Customer Complaint Notification — weld nut

Complaint no.	C-OEMN-2026-0331	Date issued	2026-09-23
Supplier	Componentes Arga S.L.	Supplier code	ARGA
Supplier part no.	AR-1010	OEM drawing no.	ON-121455 rev. C (fictitious)
Special characteristic	Weld nut torque (SC)	Quantity NOK (confirmed)	12
Supplier lot (label)	L26252-AR1010-01	Suspect qty delivered	2,760 pcs
Supplier delivery notes	AL-26-00572 — 1,380 pcs, shipped 2026-09-16 AL-26-00573 — 1,380 pcs, shipped 2026-09-14	Detected at	OEM Norte e-drive module line (inverter fixing, station ED-4)
Part description	Power inverter bracket	Repeat indicator	Not evaluated

Fig. 1 — Nut face after push-out: flattened projections and bright residue (scale bar 5 mm).

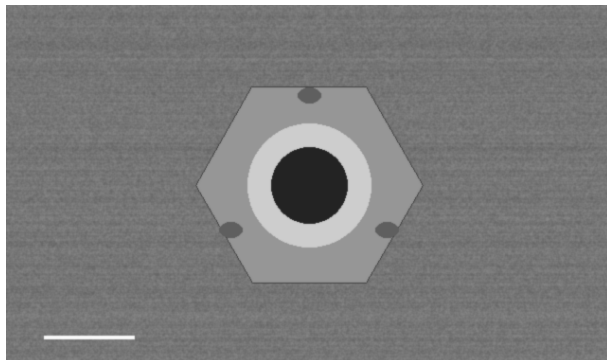
At the e-drive module line, the M8 inverter fixing bolt is tightened to 25 Nm. On 2026-09-22, **12 power inverter brackets** were found with the **M8 weld nut spinning** during tightening; the inverter could not be fixed and the modules were taken off-line. All NOK parts carry the supplier label **L26252-AR1010-01**.

Test (OEM Norte lab, report LAB-ON-26-4519)	Requirement	Result on 10 parts of the same lot
Torque-out of weld nut	≥ 40 Nm	7 parts at 19–31 Nm; 3 parts at 42–47 Nm
Push-out force of weld nut	≥ 4.0 kN	2.1–2.9 kN on the 7 low-torque parts
Interface after push-out	—	Projections flattened but not fused; bright metallic residue on the nut face

- Containment within 24 h** (due 2026-09-24): block all suspect stock at the supplier and in transit, sort OEM Norte stock through your resident team or a third party, and confirm the suspect scope from your own traceability (production lots, material lots and delivery notes), not only from the lot on the label. Certified parts must carry a clean-point label.
- 8D report within 10 working days** (due 2026-10-07) using the **OEM Norte 8D Report v3** (form OEMN-SQ-8D rev. 3). D1–D4 must be uploaded to the supplier portal before the due date; the report must be signed by the supplier's Quality Manager.
- Provide the torque-out results of your in-process checks for the complained lot and the incoming inspection records of the weld nuts used.
- Sorting, line disruption and administration costs will be handled according to the Supplier Quality Agreement.
